MEMORANDUM

To: Chuck Banas, John Norquist
From: Lucinda E. Gibson, P.E.
Date: 4 December 2007
Re: Development Opportunities Gained by a Multi-way Boulevard for Route 5

Figure 1: NYSDOT and Multi-Way Boulevard Right-of-way Options

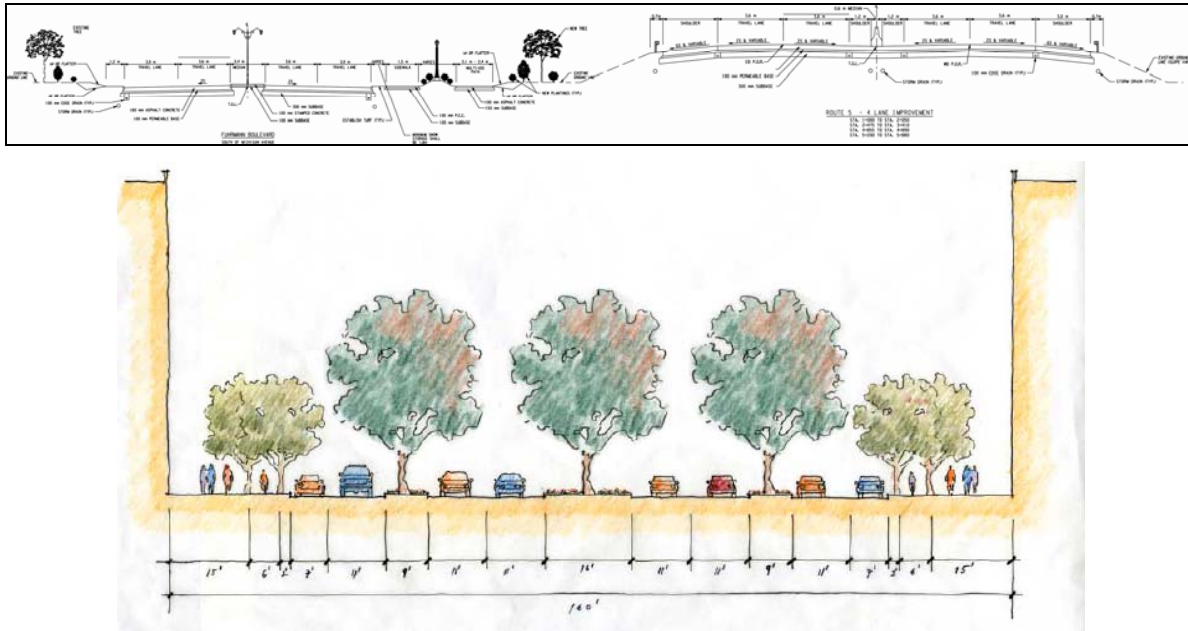
The table above shows that the NYSDOT preferred alternative has a typical cross section that is 54 feet wider, or 33% wider, than a multi-way boulevard option.

The NYSDOT option is 33% larger overall, and includes over two and a half times more pavement. There is less space allocated for landscaping, and only about one third the space for pedestrians and bicycles. The NYSDOT plan offers no space for on-street parking, which is essential for creating a welcoming urban place.

Figure 1 below illustrates the street design cross sections described in the tables above at approximately the same scale.

Figure 3: NYSDOT Preferred Alternative Plan for Ohio Street/Route 5/ NFTA Harbor area

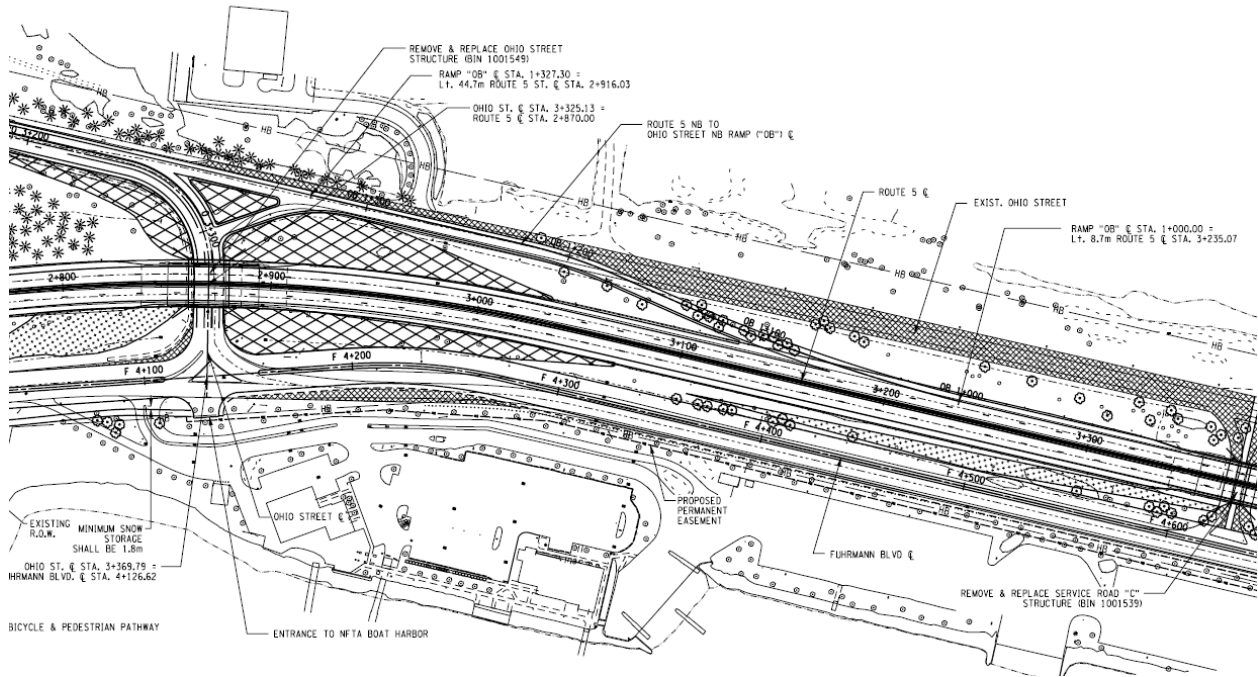
Because the Multiway Boulevard is much narrower than many portions of the existing Route 5/Fuhrmann Avenue right-of-way, this alternative will create development opportunities within the publicly owned right-of-way, which could help finance the infrastructure improvements. In addition, the Multiway Boulevard alternative will provide much greater access to other developable property. Just one example is illustrated below, along Route 5 between the NFTA Boat Harbor and the Tiff Nature Preserve. The NYSDOT plan includes a large area devoted to a grade separated interchange, which is not required in the Boulevard Plan, according to the FEIS¹.
